Town of Arlington, MA Redevelopment Board

Agenda & Meeting Notice September 18, 2023

1. Public Hearing: Docket #3766, 351 Broadway

2. Public Hearing: Warrant Articles for Fall 2023 Special Town Meeting

Main ID
Halo Lit Fabricated Letters
16-3/4"H x 2" Deep
Faces Painted Akzo Nobel 314C5 Metallic Gold
Returns Painted Black
21" x 139" x 4-1/2" Fabricated Backer
Painted to Match Building Facade

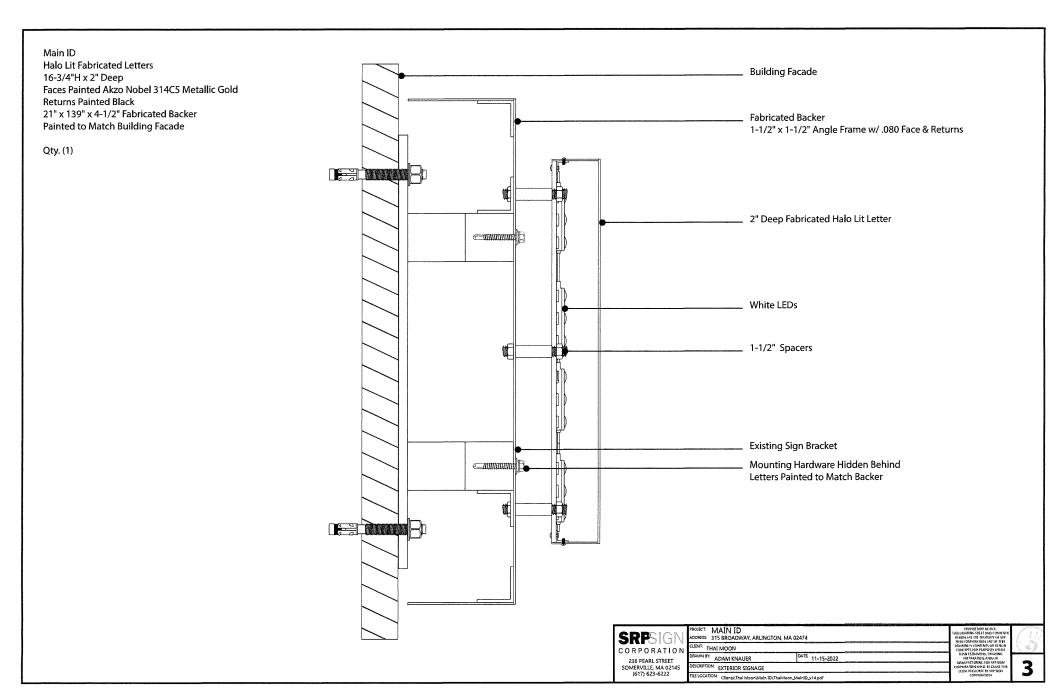
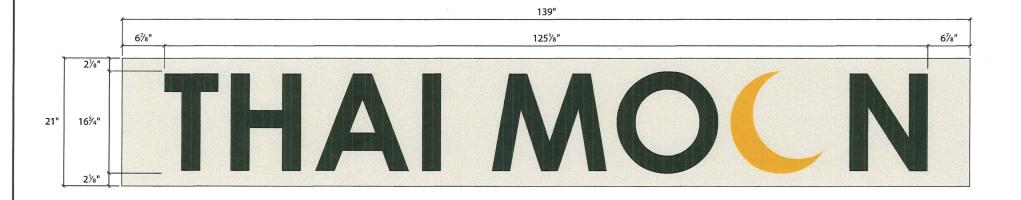
Both signs proposed in this application exceed the maximum sign width allowed based on the width of the building element and the awning face. The total sign area is within the allowable square footage. The location of the signage will not change, and the proposed signage is smaller in area than the existing signage of the former restaurant at this location. Per Section 6.2.2(C), the ARB may grant a Special Permit to allow signs of greater size and/or in a location other than what is allowed by section 6.2, "provided the architecture of the building, the location of the building relative to the street, or the nature of the use being made of the building is such that an additional sign or signs of a larger size should be allowed in the public interest."

Awning Existing Awning to be Recovered in Sunbrella Fabric Painted Gold Text on Valance

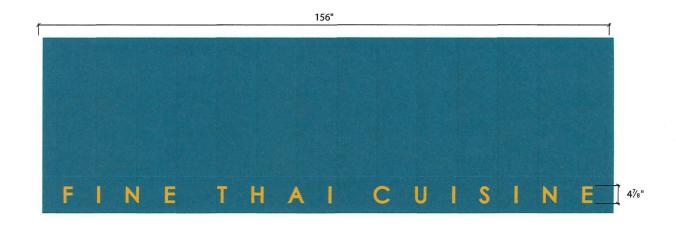
The applicant proposes to replace 1 existing exterior wall sign and 1 existing awning above the storefront of the restaurant Thai Moon, located at 315 Broadway in the Village Business Zoning District (B3) and Business Sign District. A Special Permit has been requested to allow the business to install signage in excess of what is permitted. An 10.4'-wide by 1.4'-high raceway wall sign with internal LED illumination is proposed for a storefront approximately 13' wide. The channel letters would be mounted to a 4.5" panel painted to match the color of the building façade. Also, a new, non-illuminated awning sign is proposed with 12.4'-wide by 5"-high lettering.
